INDESIT company

Model type:
ISL70CEX

Commercial code:
F030624

N1040358FIG1

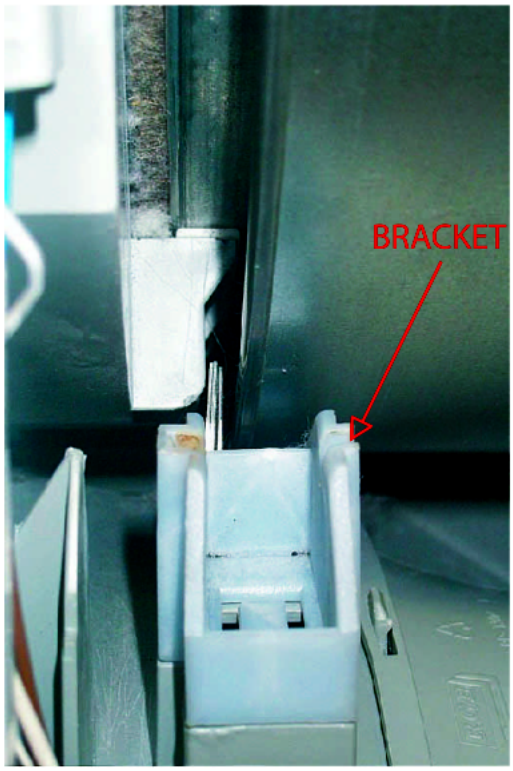
n1040358: Introduction of front bearing pads.

How to fit in premodification products.

Convert drum front support to run on bearing pads.
Remove the two wheels supporting the drum front from their locating brackets but leaving the two brackets attached to the base assembly. See N1040358FIG1.
Remove the front panel and air duct assembly and fit 5 bearing pads into the locating slots on the air duct assembly. See N1040358FIG2. Replace both the rear bearing and the drive belt to the 6 rib version.

As from s/n 50131.0001 the front suspension changed on production of all condenser dryers from wheels to bearing pads as described above.

Parts needed:
5 X Front Bearing pad code C00112144 item 350
1 X Rear Bearing code C00113862 item 503
1 X Belt code C00116358 item 556

The above parts are available in the kit code C00118931.

N1040369FIG1

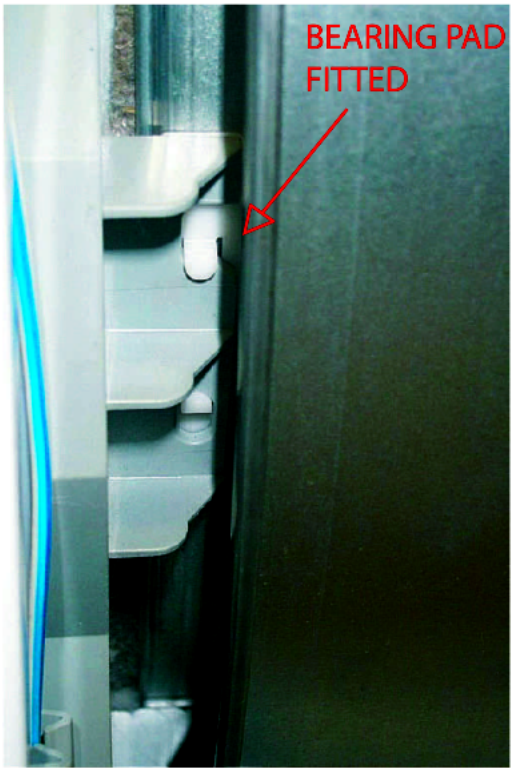
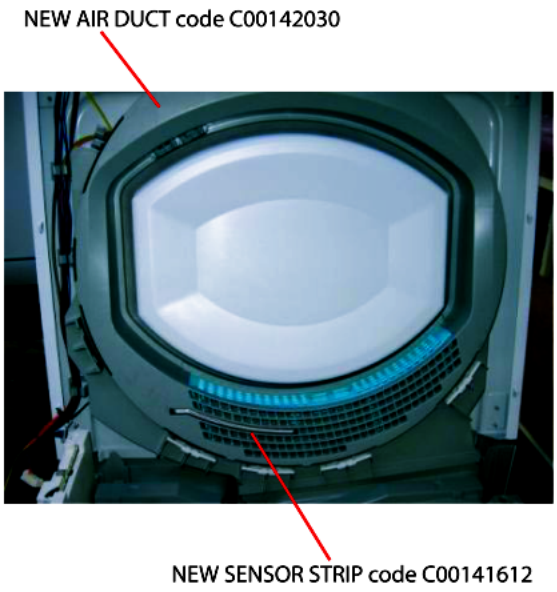
n1040369: Sensor, heating element and thermostat modified on condenser dryers.

From serial no. 50712.0001, the following parts have been introduced progressively on condenser dryers:
- new sensor (figure N1040369FIG1);
- new heating element;
- new thermostat.

New parts:
C00142030 - front air duct - (ref.330)
C00141612 - sensor strip - (ref.330)
C00141607 - drum support (there are 2 on all dryers) - (ref.545)
C00142303 - heating element - (ref.522)
C00142302 - heating element for ASL70CSK - (ref.522)
C00142587 - heating element for ISL70CSK - (ref.522)
C00141606 - thermostat kit - (ref.521)
C00142300 - thermostat kit for ASL70CSK - (ref.521)

premodification parts:
C00113855 - front air duct - (ref.330)
C00113817 - sensor brush - (ref.533)
C00113816 - brush bracket - (ref.533)
C00113838 - insulating material for sensor strip - (ref.538)
C00113837 - sensor band - (ref.539)
C00112186 - drum support - (ref.545)
C00113836 - sensor brush bracket - (ref.546)
C00115746 - heating element - (ref.522)
C00116600 - heating element for ASL70CSK / ISL70CSK - (ref.522)
C00116598 - thermostat kit - (ref.521)

The eeprom and circuit diagram were also affected by the modification (Figure N1040369FIG2).

The new items are not interchangeable with the premodification ones.

The replacement eeprom codes and relevant serial number are listed below.
New C00142039 - premodification C00115756 - s/n 50809.0001 - cc 33620 - ADE70CFR
new C00119909 - premodification C00114814 - s/n 50712.0001 - cc 33619 - ALE70CFR
new C00119912 - premodification C00115751 - s/n 50801.0001 - cc 30643 - ASD70CEX
new C00119914 - premodification C00114817 - s/n 50801.0001 - cc 30645 - ASL70CEX
new C00119915 - premodification C00114816 - s/n 50712.0001 - cc 30648 - ASL70CSK
new C00142040 - premodification C00114838 - s/n 50722.0001 - cc 30621 - ISL65CEX
new C00142041 - premodification C00114822 - s/n 50804.0001 - cc 30624 - ISL70CEX
new C00142042 - premodification C00114832 - s/n 50811.0001 - cc 30622 - ISL70CNL
new C00142043 - premodification C00142582 - s/n 50810.0001 - cc 30625 - ISL70CSEX
new C00142044 - premodification C00119971 - s/n 50816.0001 - cc 34178 - ISL66CXEX
new C00142588 - premodification C00114834 - s/n 50802.0001 - cc 30627 - ISL70CSK

N1040400FIG1

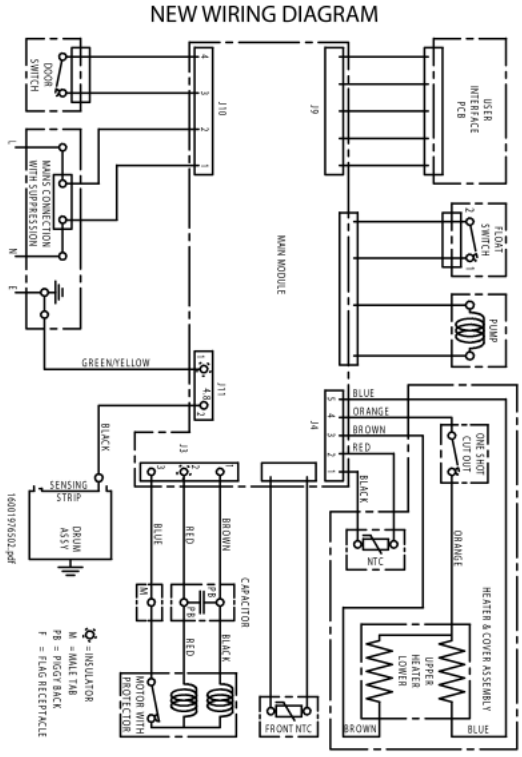
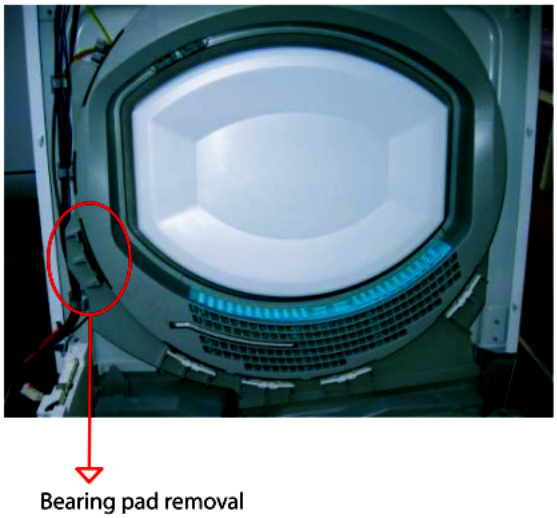
n1040400: Bearing pad removed from condenser dryers.

From serial no. 51031.0001, four bearing pads (C00112144) have been installed on dryers instead of five (see figure N1040401FIG1).

From 30.01.10 the front air duct assembly will be modified by removal of the 5th bearing pad fixing

N1040411FIG1

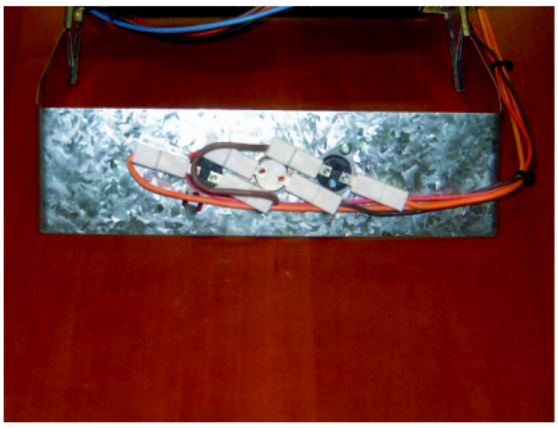
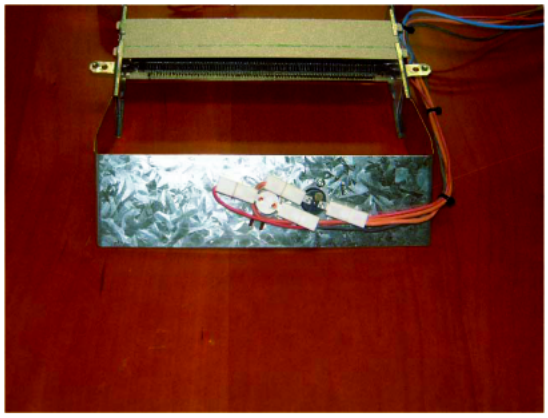
n1040411: Modifications of heating elements/thermostats on condenser dryers.

1) All appliances with serial number prior to 50712.0001 are equipped with a heating element assembly (fig1) with the following thermostats:
a) one-shot
b) cycling
c) ntc

2) From serial no. 50712.0001 the cycling thermostat has been eliminated, the heating element assembly (fig.2) is composed of the following thermostats:
a) one-shot
b) ntc

3) From serial no. 51130.0001 the ntc thermostat has been modified, the modification also introduced a new eeprom with software 28XXXXX0008, the heating element assembly (fig.2) is composed of the following thermostats:
a) one-shot
b) ntc (Tod)

4) From serial no. 60109.0001 the cycling thermostat has been reintroduced, the heating element assembly (fig.1) is composed of the following thermostats:
a) one-shot
b) cycling
c) ntc (Tod)

Replacement P/Ns for models with serial number prior to 51130.0001:

C00258828 - heating element assembly (with one-shot + cycling + ntc sensor)
C00258813 - heating element assembly (with one-shot + cycling + ntc sensor) for SK dryers
C00116598 - thermostat kit (one-shot + cycling)
C00113830 - ntc thermostat
Important
When replacing the thermostats on models with serial numbers from 50712.0001 to 51130.0001 order the assembled heating element.

Replacement P/Ns for models with serial number subsequent to 51130.0001:
C00258799 - heating element assembly (with one-shot + cycling + new ntc sensor)
C00258800 - heating element assembly (with one-shot + cycling + new ntc sensor) for SK dryers
C00116598 - thermostat kit (one-shot + cycling)
C00143511 - ntc thermostat (new Tod)
Important
When replacing the thermostats on models with serial numbers from 51130.0001 to 60109.0001 order the assembled heating element.
